Report: TAB Report
Function: Test, Adjust, & Balance
Date: 09/04/2025
Completed By: National TAB

PROJECT
08-25-25 CAVA DANBURY, CT

Project: 08-25-25 CAVA DANBURY, CT

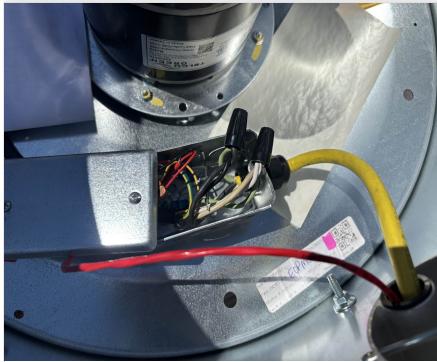
Issue Name : HD1: Small Penetration in Canopy
Description : Small penetration in hood canopy high up on right side. Recommend repairing according to manufacture directions.
Created By : National TAB **Assigned To :** National TAB - Dan Hertenstein
Status : Open
Priority : Low **Asset Tag :**
Originated Date : 08/25/2025 - Ryan Smith - National TAB

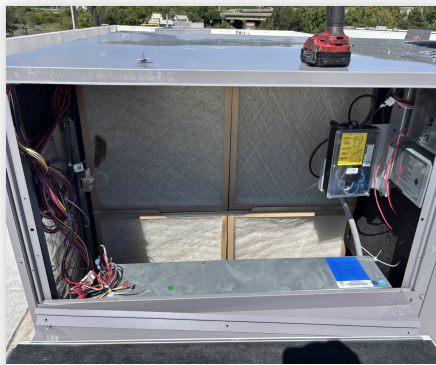
Issue Name : Rooftop Assets & Thermostats: No Identification Tags
Description : No permanent tags or labels to identify rooftop units as RTU1, RTU2, MAU, KEF1. Also no permanent tags or labels to identify which thermostat serves which area.
Created By : National TAB **Assigned To :** National TAB - Dan Hertenstein
Status : Open
Priority : Low **Asset Tag :**
Originated Date : 08/25/2025 - Ryan Smith - National TAB

- **08/27/2025 National TAB - Ryan Smith**
 - Tags have been applied to rooftop assets, but not thermostats.

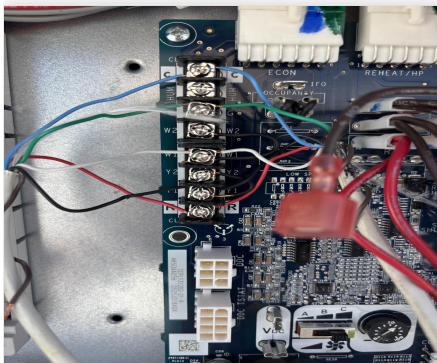
Issue Name : RTU1, RTU2: Construction Filters Still Installed
Description : Construction filters still installed in both RTUs. Recommend replacing with MERV8 filters.
Created By : National TAB **Assigned To :** National TAB - Dan Hertenstein
Status : Open
Priority : Medium **Asset Tag :**
Originated Date : 08/25/2025 - Ryan Smith - National TAB

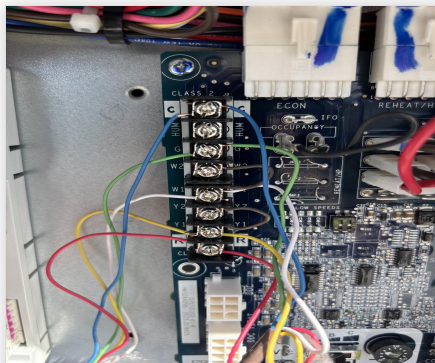
Issue Name : RTU1, RTU2: Controller Wiring Incorrect
Description : Controllers in RTUs are wired incorrectly. Y1 is jumped to Y2 and W1 is jumped to W2. Also, thermostats do not send occupancy signal to correct terminal on board, only toggling fan mode instead.
Created By : National TAB **Assigned To :** National TAB - Dan Hertenstein
Status : Open
Priority : Low **Asset Tag :**
Originated Date : 08/27/2025 - Ryan Smith - National TAB

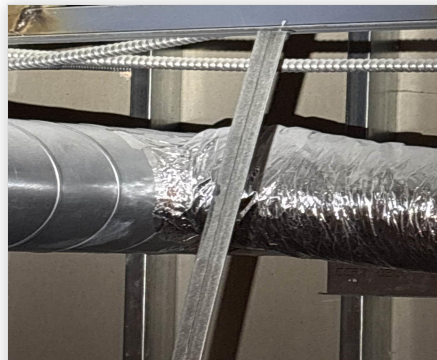
Issue Name : RTU2-10,12: No Dampers in Bathroom Supply Diffusers
Description : Bathroom supply diffusers do not have dampers. Unable to adjust.
Created By : National TAB **Assigned To :** National TAB - Dan Hertenstein
Status : Open
Priority : Low **Asset Tag :**
Originated Date : 08/27/2025 - Ryan Smith - National TAB

Asset: RTU1

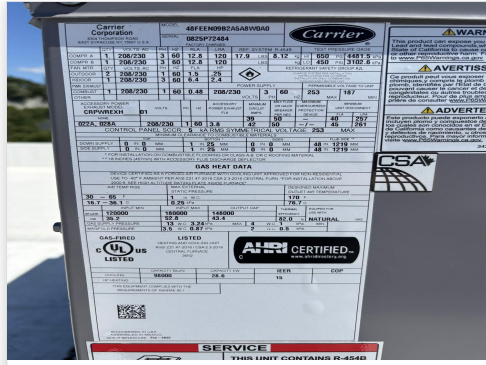
Notes:
ACPSP does not have dampers. Not able to adjust diffusers. Only balanced total airflow on entire unit.

Asset: RTU2

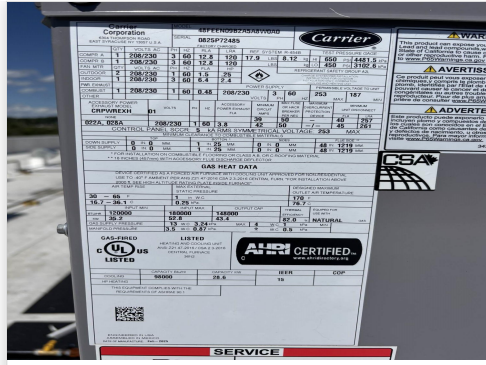
Notes:
Balanced total flow only because dining area diffusers were not accessible.

No dampers in bathrooms.
